CALIFORNIA COASTAL COMMISSION

STAFF REPORT: REGULAR CALENDAR

APPLICATION NO.: 4-98-214

PROJECT DESCRIPTION: Construct a 1,322 sq. ft. two story garage & studio to existing single family residence, new septic tank, and 'unpermitted' concrete underpinning of an existing vertical seawall/bulkhead, including a new offer to dedicate lateral public access.

EXHIBIT NO. 9
APPLICATION # 219
Bulk head
Underpinning

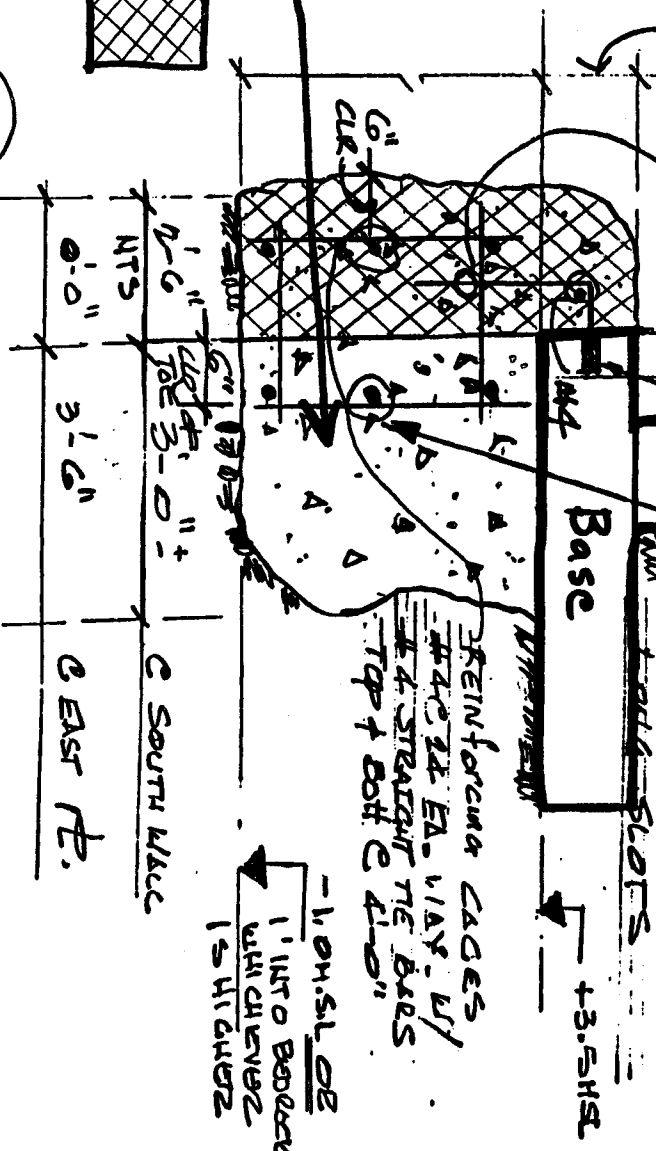
In this case, the proposed 'unpermitted' underpinning of the existing vertical concrete bulkhead exceeds the applicable stringline setbacks of adjoining seawalls/bulkheads and would result in seaward encroachment of development on Amarillo Beach. In addition, the proposed addition to this residence is located on the landward side of the existing residence well beyond the stringline of the residence. Staff notes that the applicant's consultant has identified a potential project revision that would redesign and relocate these structures sufficiently to achieve the necessary alignment with the stringline. Special Condition Number One (1) sets forth these requirements to bring the project to a location within the stringline. This condition requires revised project plans identifying the removal of the seaward encroachment of the 'unpermitted' concrete underpinning located beneath the existing vertical concrete wall and footing. The revised plans must be prepared and signed by a licensed engineer(s) with expertise in designing shoreline protective devices and will identify the entire length of the existing vertical bulkhead, the underpinning and the removal of the seaward encroachment of the underpinning located beneath the existing footing of the bulkhead.

18, and March 2, 1998. The underpinning encroaches between two and a half (2 ½) to three and three quarters (3 ¾) feet seaward of the seaward toe of the base of the vertical bulkhead located along an approximate eighty-two (82) foot long seaward boundary. As a result, the actual physical displacement of sandy beach that is available for public recreation or access during beach scour periods is about 250 square feet in this case. As discussed below, the potential adverse effects to the beach profile resulting from scour effects of the bulkhead may affect public access and recreation on the beach.

The applicant's engineer also provided a clarifying letter titled: Underpinning of Existing Concrete Bulkhead Wall at 23910 Malibu Road, dated July 2, 1999. This letter included a copy of the original plans for the concrete bulkhead approved by the Commission in 1987. The original design specified that the toe of the footing would extend 1' 3" beyond the seaward face of the wall. Seaward of this footing, the 'unpermitted' underpinning extends about 2' 6" and 3' 9" seaward of the existing toe of the wall.

1. Revised Plans for Removal of Seaward Encroachment of Seawall Underpinning and Provisional Term for Shoreline Protective Structure: Deed Restriction
 - A. Prior to issuance of coastal development permit, the applicant shall submit for the review and approval of the Executive Director, revised project plans removing the portion of the 'unpermitted' concrete underpinning that encroaches seaward of the existing vertical concrete bulkhead. The revised plans shall be prepared and signed by a licensed engineer(s) with expertise in designing shoreline protective devices. The revised plans shall identify the entire length of the existing vertical bulkhead, the underpinning and the removal of the seaward encroachment of the underpinning located beneath the existing footing of the bulkhead. The revised plans shall indicate that the applicant or successors in interest shall complete the removal by the end of the winter season of the year 2002, or no later than March 31, 2002. The intent of this time frame is to allow the applicant or successors in interest two winter seasons when the beach may be naturally scoured to a cobble beach or thin sandy beach to complete the removal of the seaward portion of the underpinning.

- B. The applicant or successors in interest shall complete the required removal of the seaward portion of the underpinning no later than March 31, 2002. The applicant or successors in interest shall also submit documentation for the review and approval of the Executive Director including photographs and 'as built' plans signed by a licensed engineer within 30 days of the completion of the removal or by April 30, 2002, whichever is sooner, indicating that the entire seaward portion of the underpinning is removed as measured from the seaward end of the supporting base of the existing vertical concrete seawall.

Underpinning
 Area to be Removed per Condition #1

EXHIBIT NO. 11
 APPLICATION 1984
 Approved Seawall & Deck Expansion

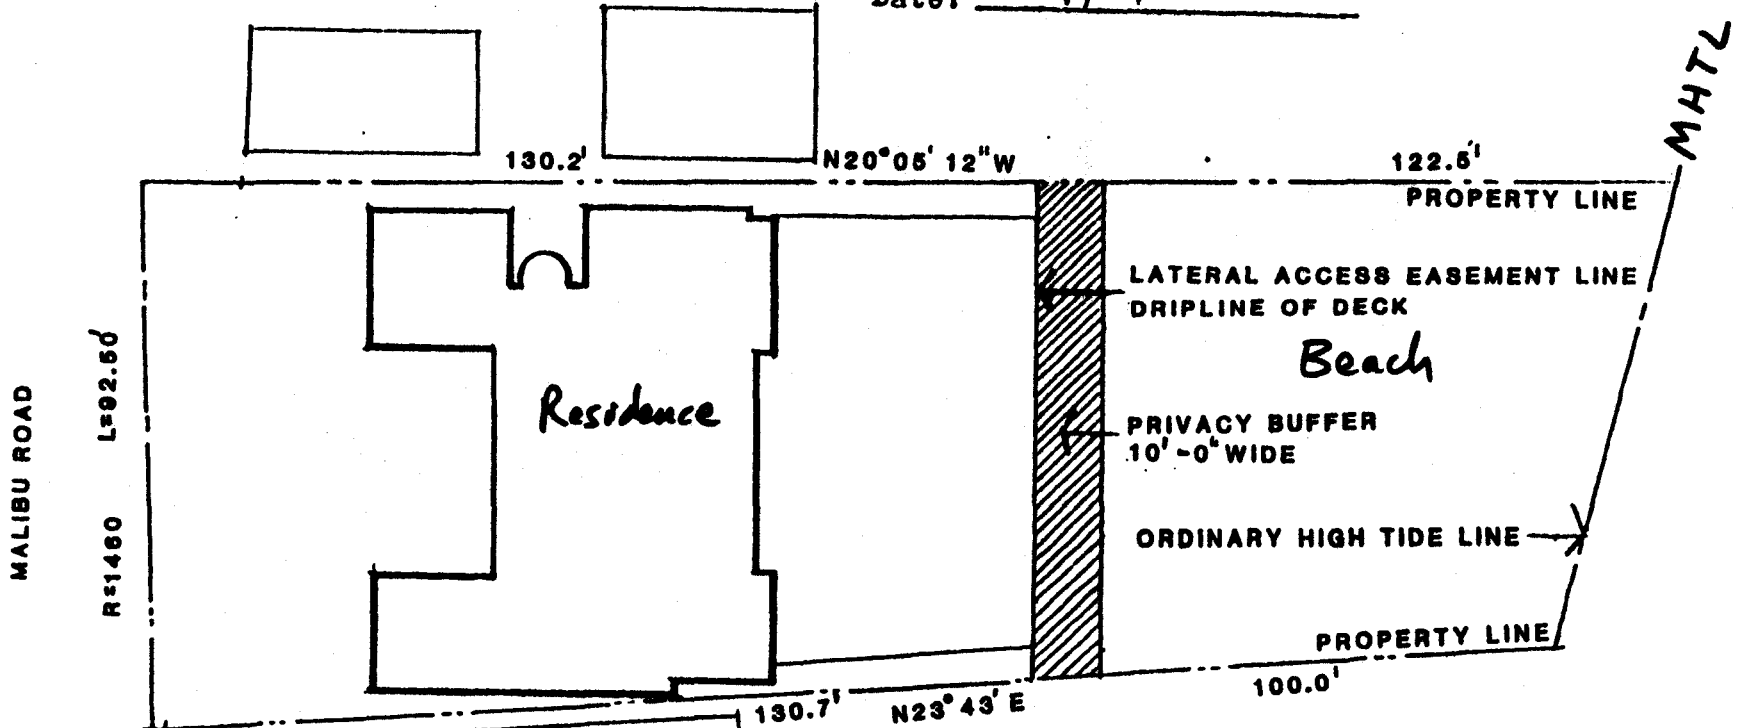
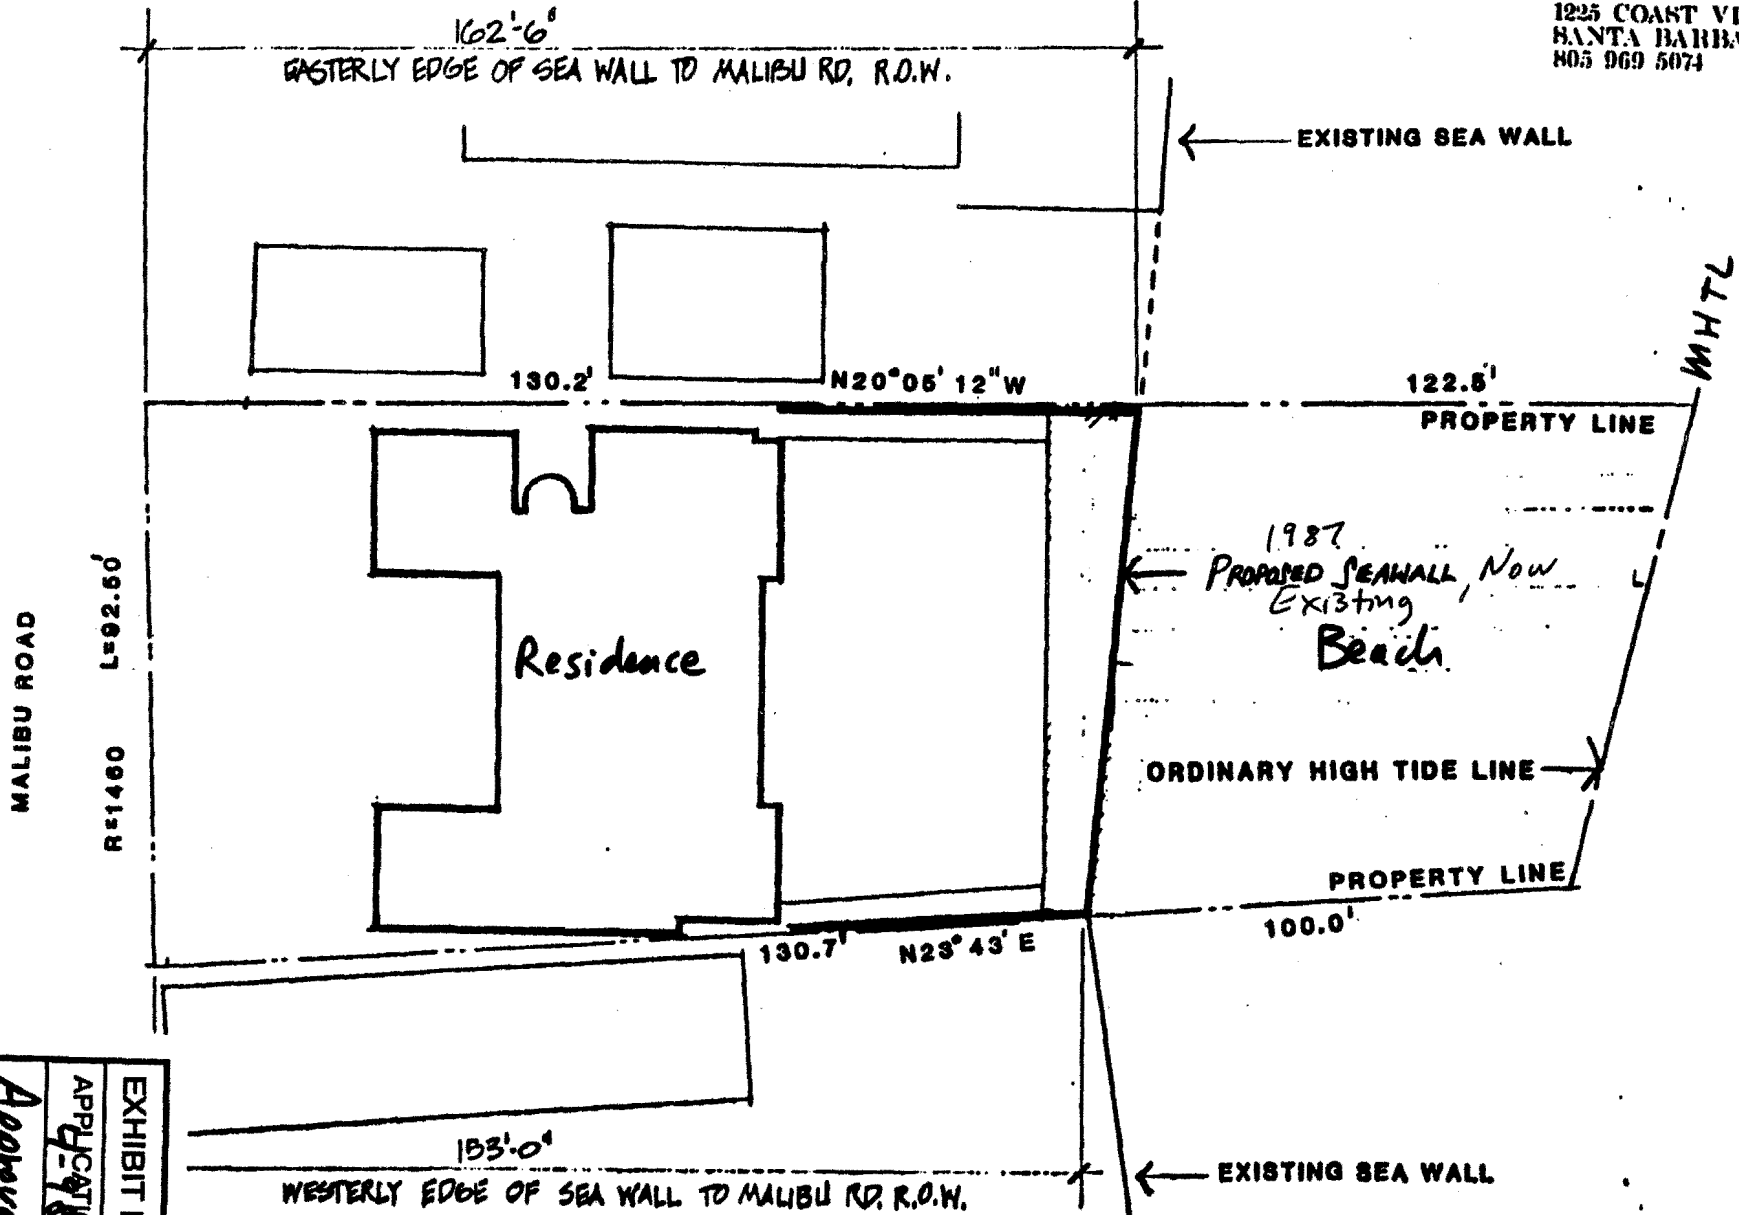
With respect to the subject site, the adjacent properties upcoast to the west and downcoast two lots to the east are developed with residences and have similar concrete bulkheads which also protects their respective residences. The adjoining residence to the east is a smaller residence without an apparent seawall or bulkhead. These bulkheads are located in the same alignment as this subject bulkhead. The submitted plans indicate that the proposed concrete underpinning will be located, as conditioned, to conform to and connect to the existing bulkheads on the adjoining property to the west and to the east the property one lot away from the subject lot. The applicant's consultant, David Weiss a registered coastal engineer, has prepared, stamped, and signed the submitted plans.

The applicant has submitted a plan identifying the stringline by locating the vertical bulkhead in relation to the existing bulkheads on either side of the project site (Exhibit 11). The plan indicates that the bulkhead is located within the stringline of the adjacent bulkhead to the west and the bulkhead located one lot beyond the adjoining lot to the east. The adjoining lot and residence located to the east does not have a bulkhead or seawall. However, the underpinning as discussed above in this report does encroach further seaward beyond the toe of the base of the vertical seawall. Therefore, the Commission finds that the proposed "unpermitted" underpinning does not conform to this setback. As required by Special Condition Number One (1) the applicant is required to remove the seaward encroachment of the underpinning by March 31, 2002.

Site Plan with New Access Offer

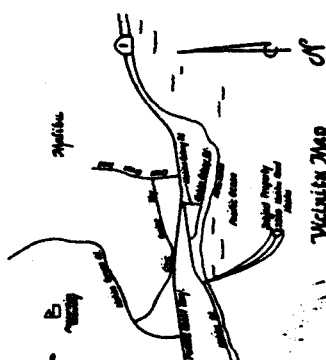
Staff continued to review this application as there appeared to be a discrepancy in the measurements on the numerous site plans submitted by the applicant. A discrepancy was discovered during the review of the site plan overlaid with the recorded lateral access easement as compared to a site plan with the approved vertical bulkhead. The discovery revealed that the vertical bulkhead and a portion of the deck are located within the recorded lateral access easement area (Exhibits 10 and 11). The Commission approved Permit Amendment No. 5-85-512-A-2 to replace the existing (in 1987) sub-grade riprap protection barrier with a vertical concrete bulkhead and a sub-grade rock erosion and wave barrier to be located approximately 35 feet landward of the existing sub-grade rock. The then proposed vertical bulkhead was to be located at the base of the proposed deck and tie in with the nearest adjacent vertical bulkheads consistent with the stringline. The result of this amendment was to allow the construction of the vertical bulkhead and an extension of the deck into the recorded lateral access area. A review of the plans indicates that the vertical bulkhead and deck expansion encroaches between 22 and 32 feet into the lateral access area, an area of about 2,214 sq. ft. (Exhibits 10 - 12). To resolve this situation, the applicant has offered to revise the language in the lateral access easement to note that it supercedes and replaces the previous offer to dedicate a lateral access easement that was recorded in 1986. The reason a new offer to dedicate is needed is because the Commission has approved development, although unintentionally, to be located within the easement area. Special Condition Number Six (6) requires that the applicant follow through with their voluntary offer to record the revised offer to dedicate that will supercede and replace the offer to dedicate (instrument # 86-1638442, recorded on November 26, 1986).

In order to implement the applicant's proposal of a new offer to dedicate an easement for lateral public access and passive recreational use along the shoreline as part of this project, the applicant agrees to complete the following prior to issuance of the permit: the landowner shall execute and record a document, in a form and content acceptable to the Executive Director, that supercedes and replaces the Irrevocable Offer to Dedicate Public Access Easement recorded on November 27, 1986, as instrument no. 86-1638442 in the County of Los Angeles, irrevocably offering to dedicate to a public agency or private association approved by the Executive Director an easement for lateral public access and passive recreational use along the shoreline. The document shall provide that the offer of dedication shall not be used or construed to allow anyone, prior to acceptance of the offer, to interfere with any rights of public access acquired through use which may exist on the property. Such easement shall be located along the entire width of the property from the mean high tide line landward to the face of the seawall/bulkhead as illustrated on the revised site plan prepared pursuant to Special Condition 1 above, and approved by the Executive Director.

The area ten (10) feet seaward from the face of the seawall/bulkhead as illustrated on the revised final project plans prepared pursuant to Special Condition 1 shall be identified as a privacy buffer. The privacy buffer shall be applicable only if and when it is located landward of the mean high tide line and shall be restricted to pass and repass only, and shall be available only when no other dry beach areas are available for lateral public access. The privacy buffer
